REMARKS

This reply is submitted in response to the Office Action of July 14, 2004. The amendments above and remarks that follow address the points raised in the Office Action, and thereby, place this application in condition for allowance.

AMENDMENTS TO THE DRAWINGS

Figure 1

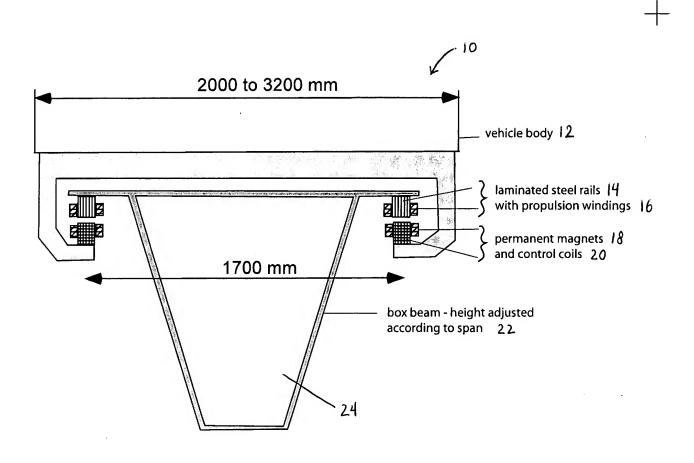
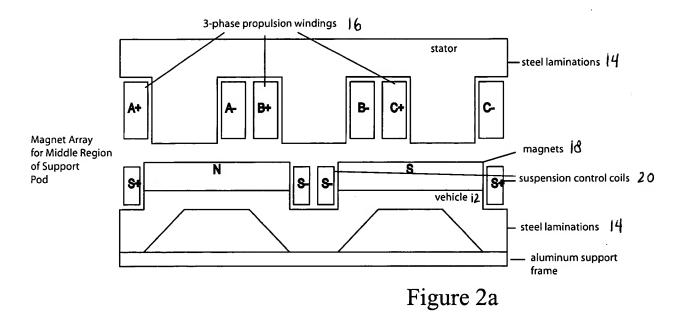
Marked up version of replacement paragraph beginning at line 13 on page 8

--Figure 1 shows a cross-section of the baseline suspension design <u>10</u> in a system according to the invention. The vehicle <u>12</u> is supported by a string of magnets <u>18</u> on each side and these magnets create attractive forces to the laminated steel rails <u>14</u> on the guideway <u>24</u>. <u>Also shown is box beam 22</u>. The dimensions shown in Fig. 1 were chosen with several factors in mind, e g.,--

Figure 2b

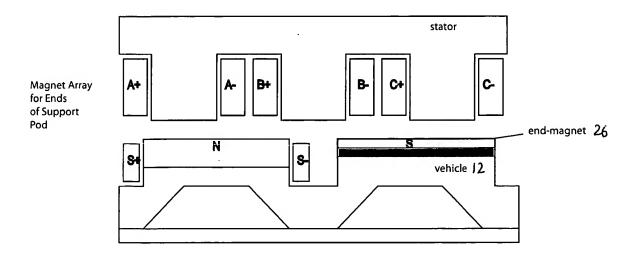
Marked up version of replacement paragraph beginning at line 4 on page 12

--In Fig. 2b, the end magnets <u>26</u> are not full height and do not have control coils. The reduced height reduces the attractive force when the magnet gap is small and this reduces the peak current required in the control coils. In some embodiments, a control coil is placed around the end magnets. A design of the end magnets could be quite different if the magnet array is very short or if higher suspension force is required, and such is envisioned herein.--

Figure 3

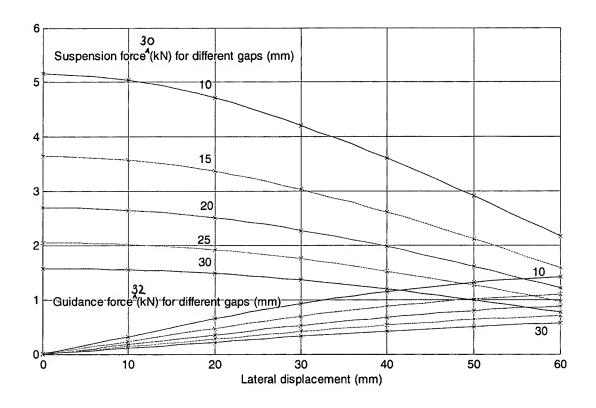
Marked up version of replacement paragraph beginning at line 25 on page 9

--Figure 3 is a graph depicting the suspension force 30 and guidance force 32 as a function of lateral displacement for a 1-wavelength (0.5 meter) section of vehicle magnets and for an 80 mm rail width, for a system such as described above. This graph was generated for magnets with an energy product of 40 mega Gauss Oersted (MGO) using 3D finite element analysis with periodic boundary conditions. The normal operation is with 20 mm vertical displacement and zero horizontal displacement and then the suspension force is 2,700 N per wavelength, as shown in the graph. The suspension will then support 550 kg of mass per meter of length of the magnet pods. The 2 half-magnets on the ends of the pods will produce additional lift of 630 N total for magnets with the dimensions and locations shown in Fig. 2b. Four pods, each with a length of 3 meters, will then lift 6,700 kg, the approximate mass of a normally loaded (i.e. 75% of the seats filled), small bus size vehicle.--

Figure 4

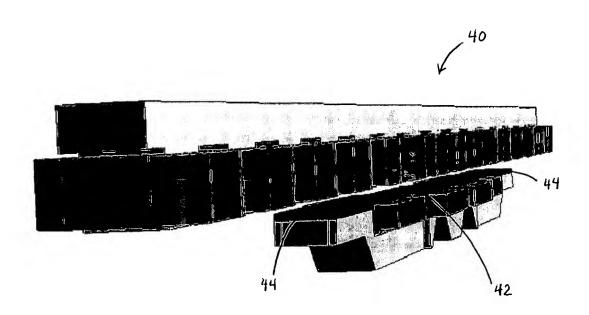
Marked up version of replacement paragraph beginning at line 1 on page 12

--The relative dimensions shown in Fig. 2b were chosen according to this criterion. A magnet pod <u>40</u> with four full magnets <u>42</u> and the two end magnets <u>44</u> is shown in Fig. 4.—

Figure 5

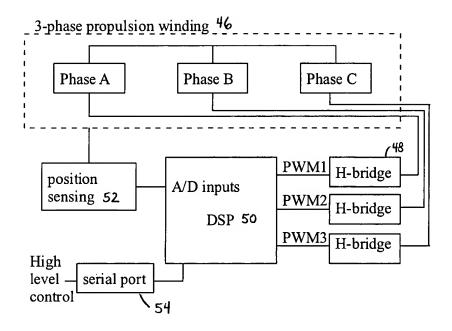
Marked up version of replacement paragraph beginning at line 37 on page 12

--Fig. 5 is a simplified block diagram of the control system for a typical pod according to the invention. The pod can have any number of control coils, here designated n, each controlled by an H-bridge $\underline{48}$, which is, in turn, controlled by a digital signal processor $\underline{50}$ (DSP). Gap and acceleration sensors $\underline{52}$ at each end of the pod provide the sensor input needed to maintain a stable gap. In practice there can be more than one processor so that there is redundancy in case of failure of the control system.--

Figure 7

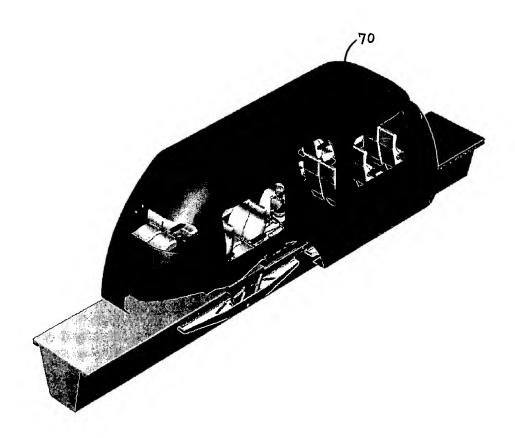
Marked up version of replacement paragraph beginning at line 27 on page 13

--Fig. 7 depicts a vehicle 70 according to the invention with four pods that pivot in two dimensions in order to allow negotiating horizontal and vertical turns. Fig. 8 shows how the magnet pods, such as those illustrated in Fig. 7, can be attached to a vehicle 80 according to the invention. Fig. 8 also shows optional mechanical mechanisms according to the invention that damp oscillations of the pods with respect to the vehicle.--
